**City Planning Commission Meeting**  
**Tuesday, March 10, 2015**

**PRELIMINARY STAFF REPORT**

**To:** City Planning Commission  
**Zoning Docket:** 020/15

**Request:** This is a request for a conditional use to permit a hotel and parking garage in the CBD-3 Central Business District with waivers of the applicable height and floor area ratio requirements of the Central Business District Height and Floor Area Ratio Interim Zoning District.

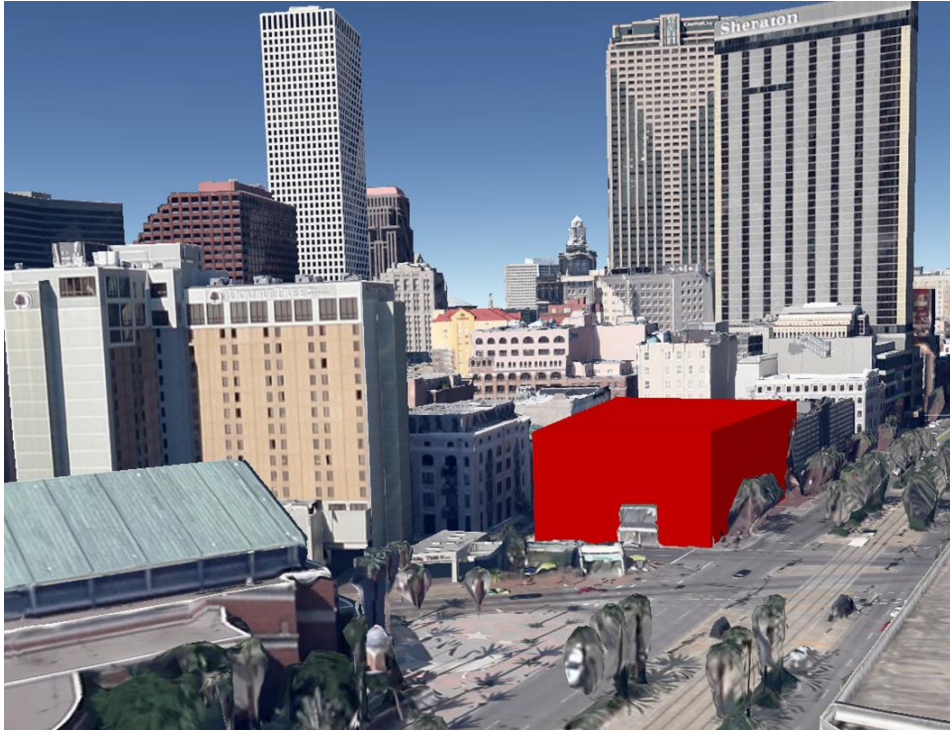
This site is located along a stretch of Canal Street that is distinctive for its historic four-to-six story buildings. By imposing a 70 foot height limit for new structures, the Interim Zoning District definitely, indisputably intends for new structures to be similar in height to those historic structures. The proposed 20-story structure would be dramatically taller

than the surrounding historic structures and in no way would respect the character and scale of the neighboring historic structures. As such, the granting of the waiver would be inconsistent with the intent of the Interim Zoning District.

Height and massing of a structure meeting the 70 foot height requirement, as viewed looking down Canal Street in a lake-bound direction.

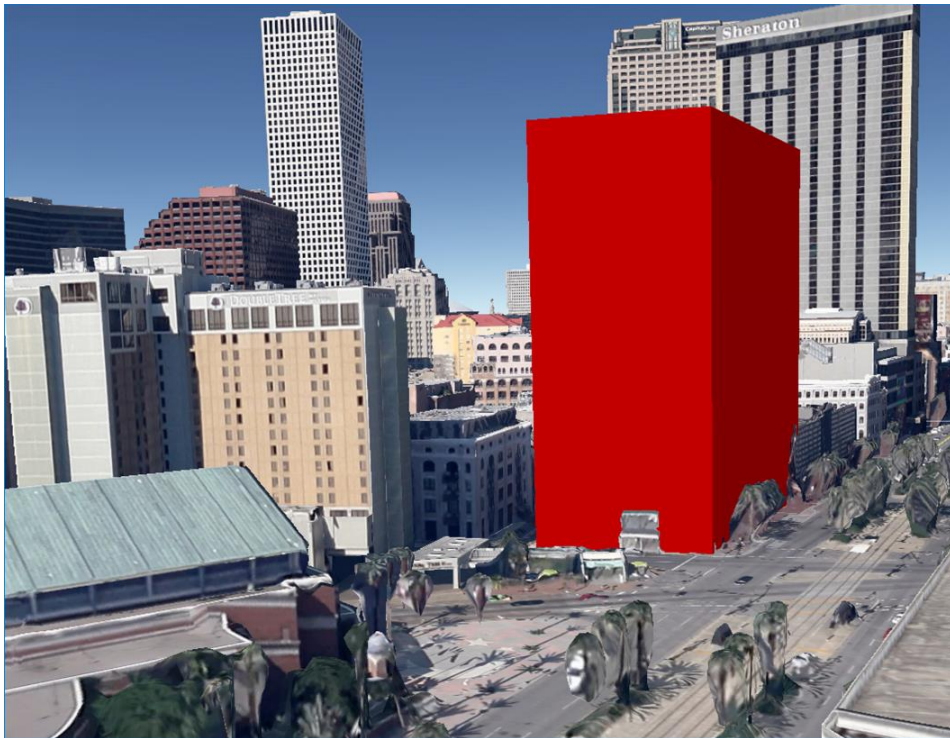
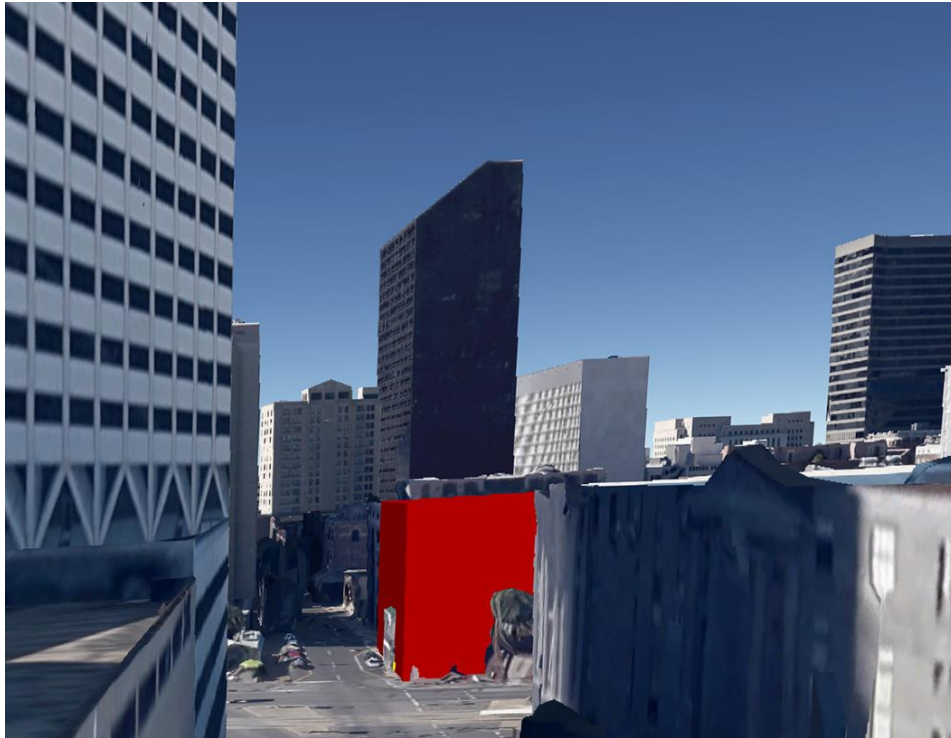
Yes, the granting of the waiver to allow the 20-story, 250 foot tall building would adversely affect the site's harmony and compatibility with adjacent land uses. The historic buildings that currently exist at the site are characteristic of this historic portion of Canal Street and are similar in height to the surrounding historic building stock, including the adjacent Sanlin buildings, the U.S. Customs House, which is located across Canal Street, and the low-rise historic structures located across Common Street from the site. Replacing these historic structures, which are completely appropriate for the site, with the proposed structure, which is completely inappropriate for the site in terms of its height, would adversely affect the site's harmony and compatibility with surrounding properties.

Because the new structure is so tremendously out-of-scale with the historic building stock that defines this portion of Canal Street and the neighboring portions of the Vieux Carré, it would transform the character of the area to its detriment. The Canal Street streetscape would be substantially altered, as its appearance would be transformed, as would the qualitative experience of walking down the street as a pedestrian. Furthermore, it would affect the quality of life for occupants of the surrounding historic buildings, as the building would block views from those properties and cast greater shadows than do the existing buildings or any new building which might be constructed at the site in the future in accordance with the height requirement.

To illustrate the fact that the proposed hotel would be extremely out-of-scale with the surrounding historic development, the staff has included the below height and massing models showing the height and massing of the proposed hotel development as compared to the height and mass of a structure meeting the 70 foot height limit. These models show that the proposed structure would dwarf its historic neighbors, adversely affecting those structures and changing the area's character as a result.

**Height and massing of a 250 tall structure, as viewed looking down Canal Street in lake bound direction.**

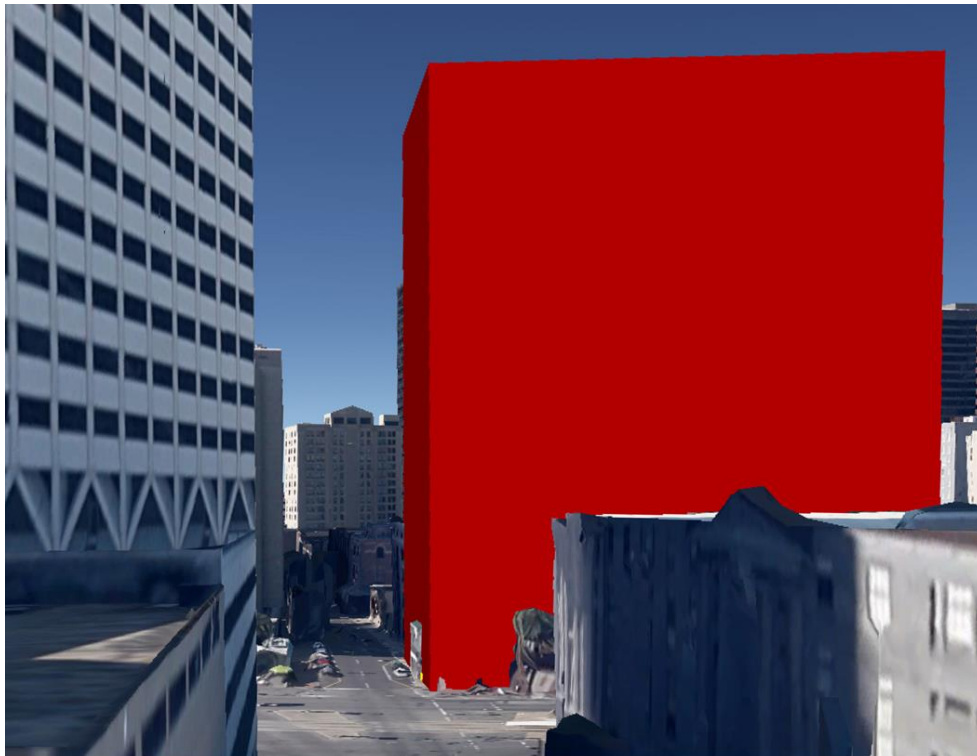
**Height and massing of a structure meeting the 70 foot height requirement, as viewed looking down Tchoupitoulas Street from North Peters Street.**
